DRAWING P101 – FIRST AND SECOND FLOOR REMOVAL PLANS

**** END OF ADDENDUM #1 ****

PVMS TOILET ROOM ALTERATIONS

CAPITAL PROJECTS PHASE 2

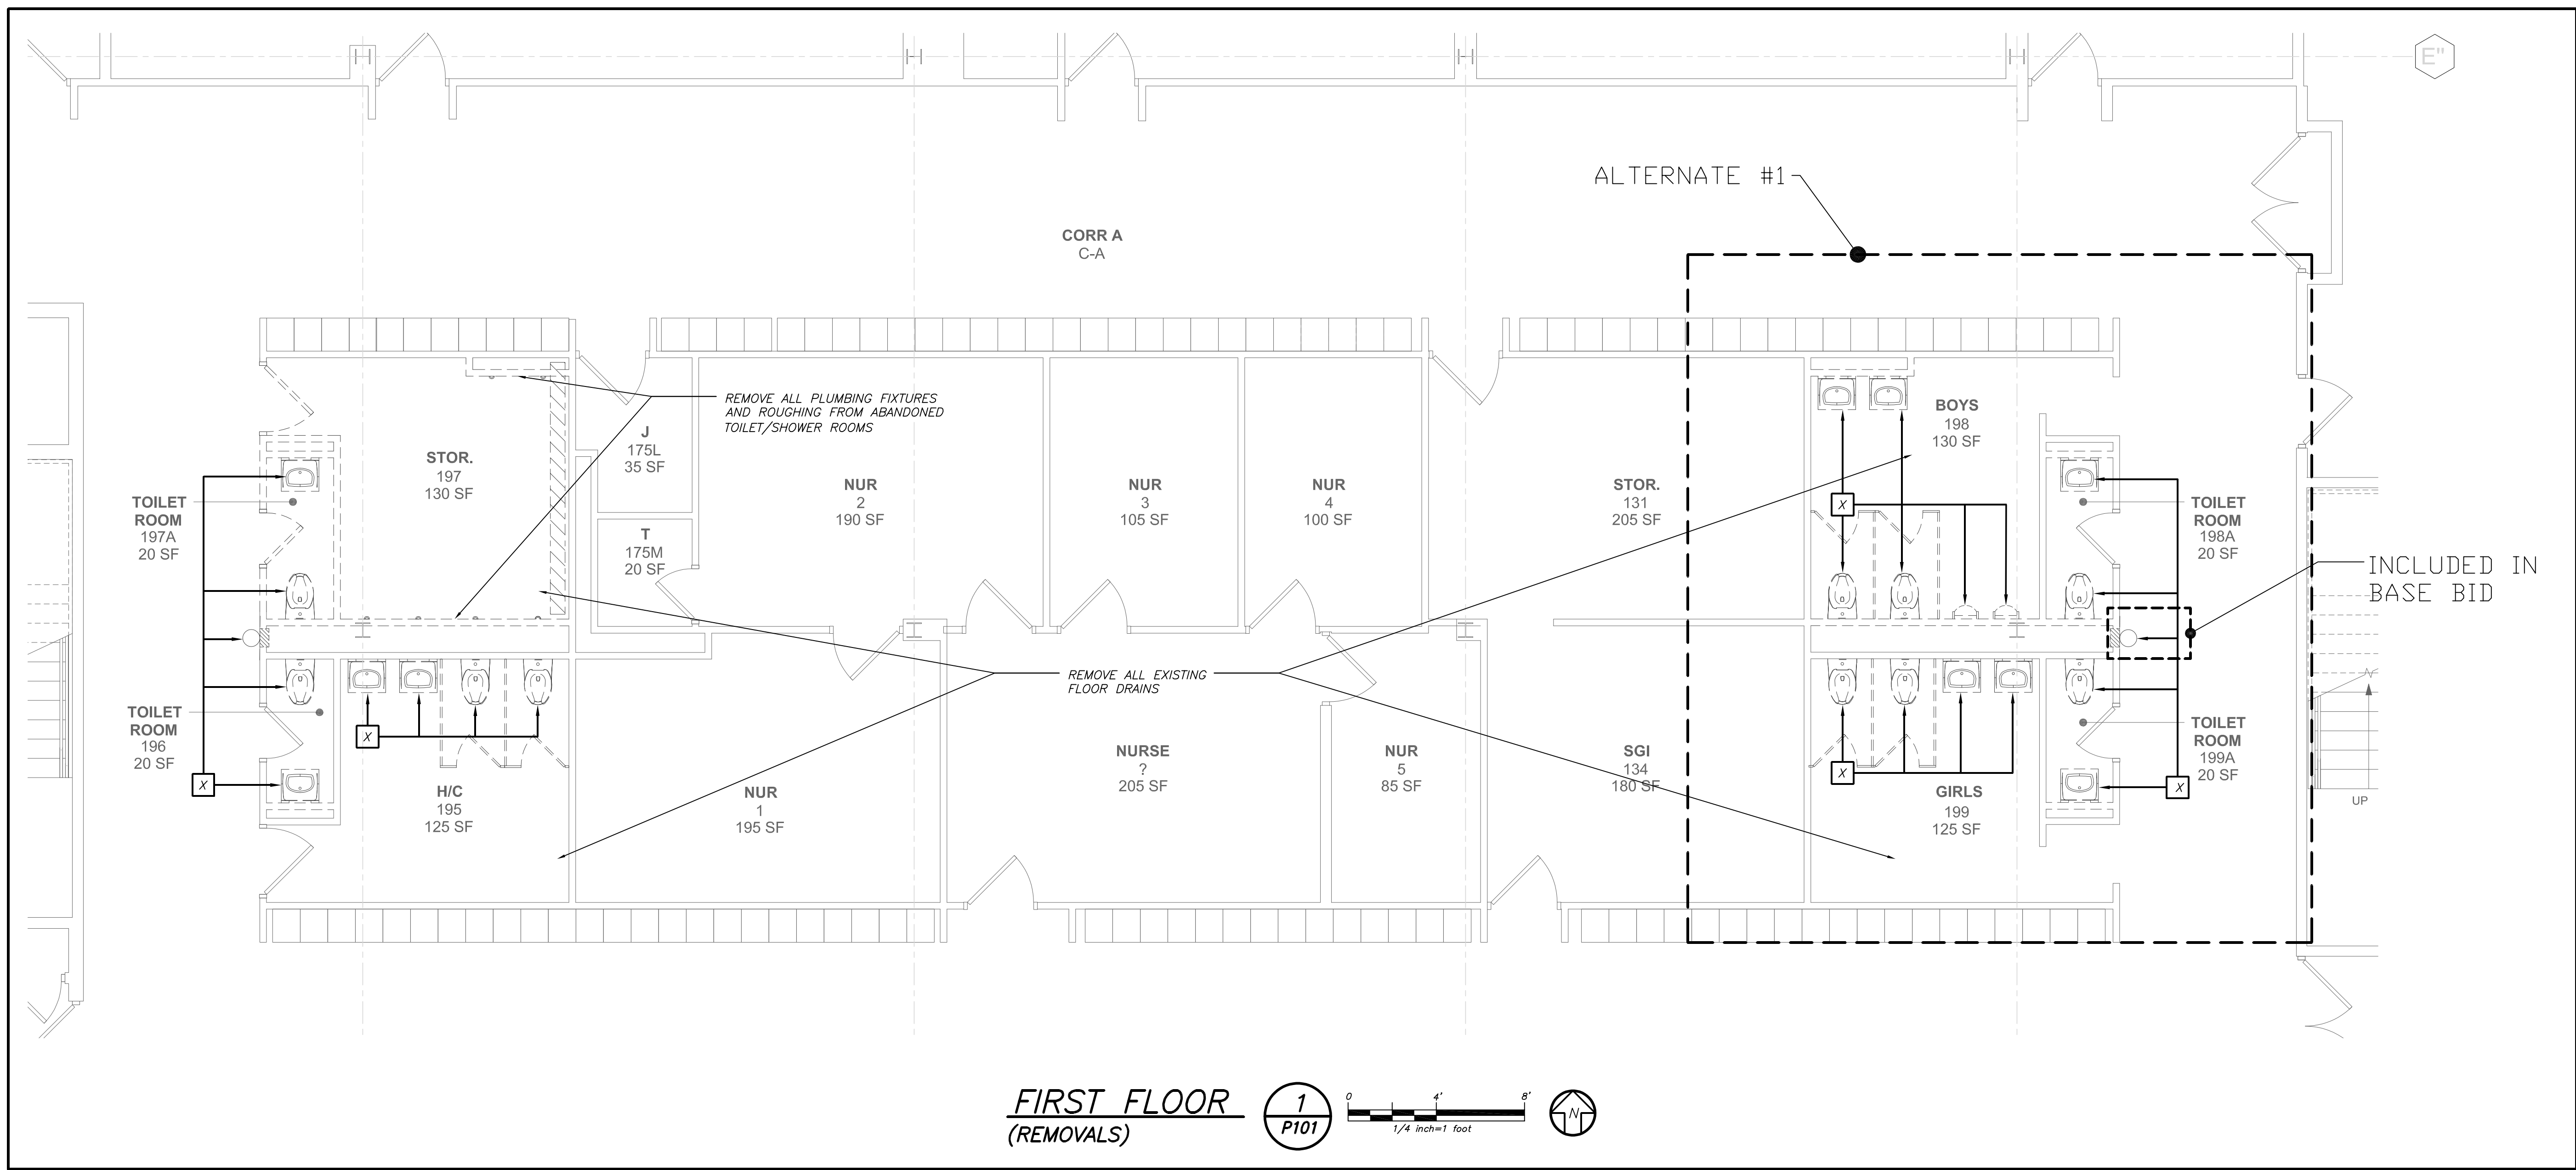
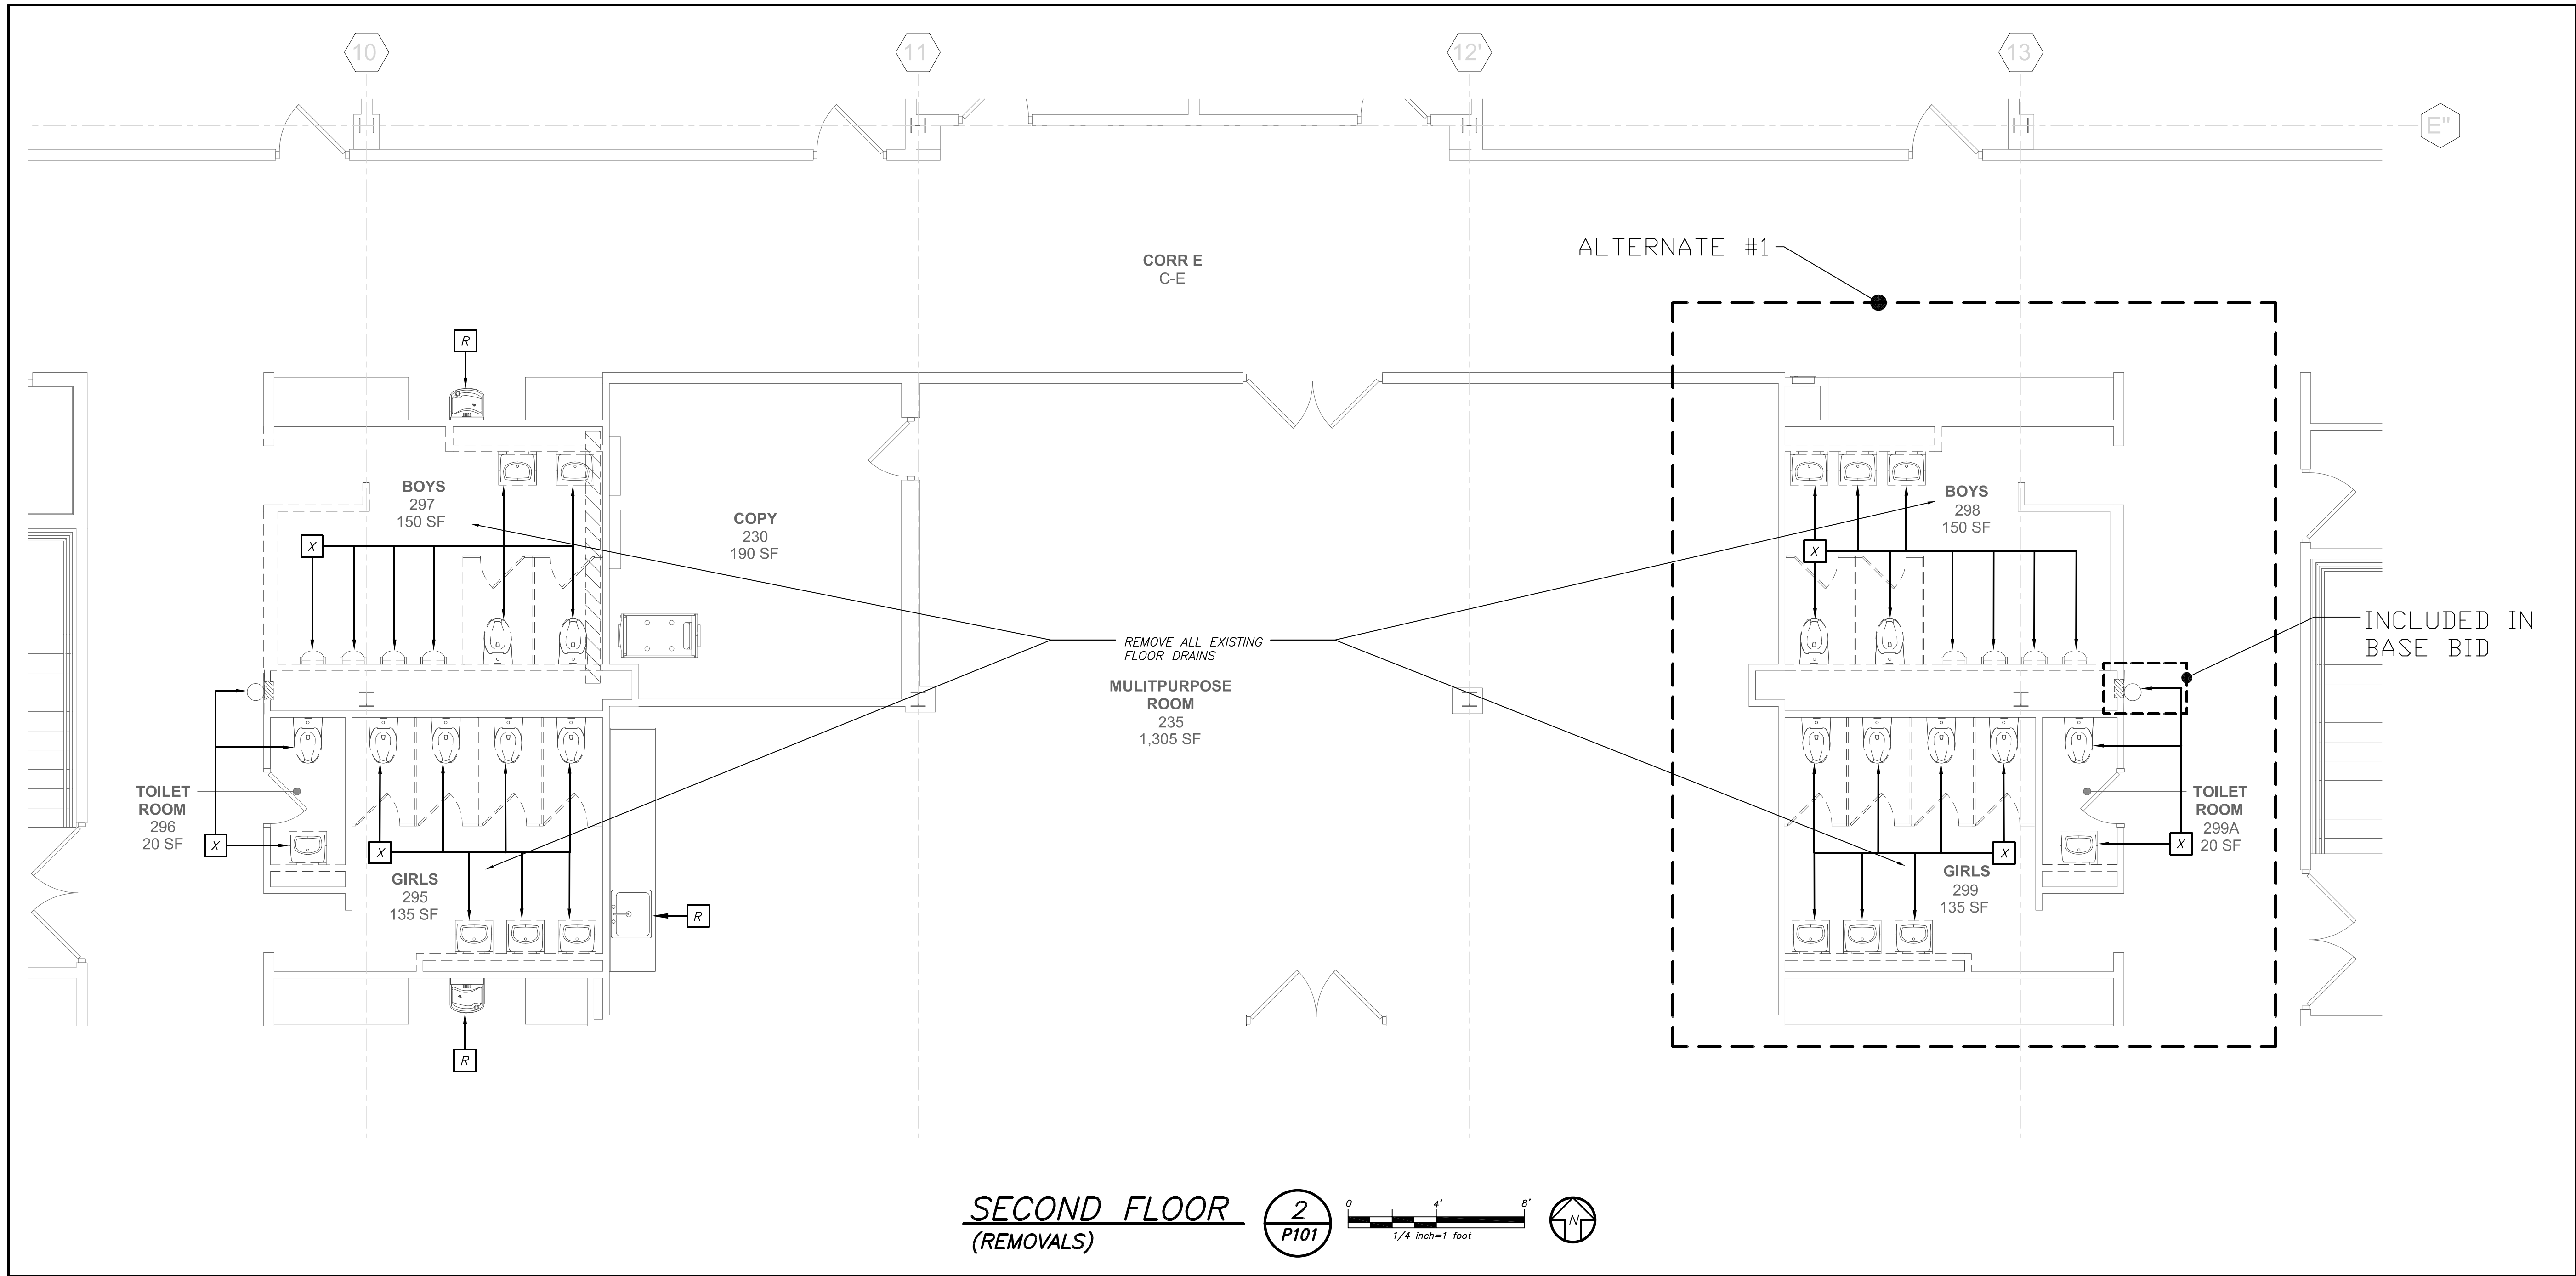
1. All water cooler replacements shall be included in the base bid. See attached drawing for reference.
